DAVID FLORIDA LABORATORY - BUILDING # 65 3701 Carling Ave., P.O.Box 11490, Station H, Ottawa, Ontario, K2H 8S2

9f023-20200546 Addendum No. 2

Project: Bay 3 HVAC Refit project No. CSA15-G8

Date Issued: March 17, 2021

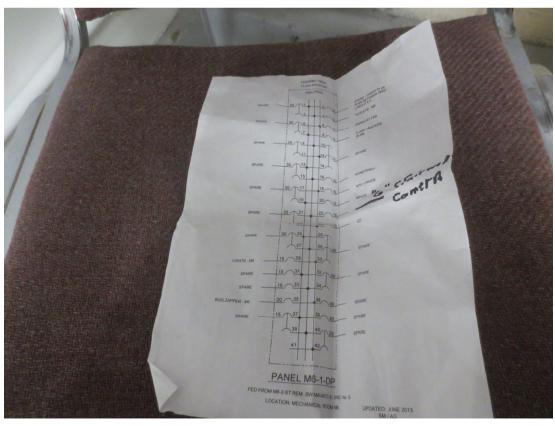
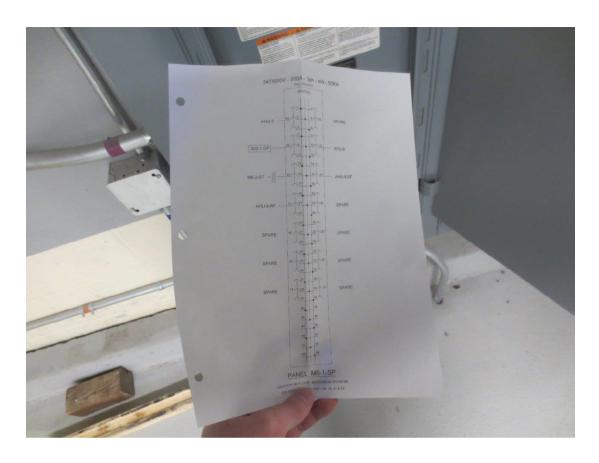
Can you specify the model of the Electrical Panel M6-1-SP (New Work) and the make, model and kA rating for Electrical Panel M6-1-DP (New Work)? Drawing Electrical Panel and Schedules and Single Line Diagram, drawing #2.

See attached photos.
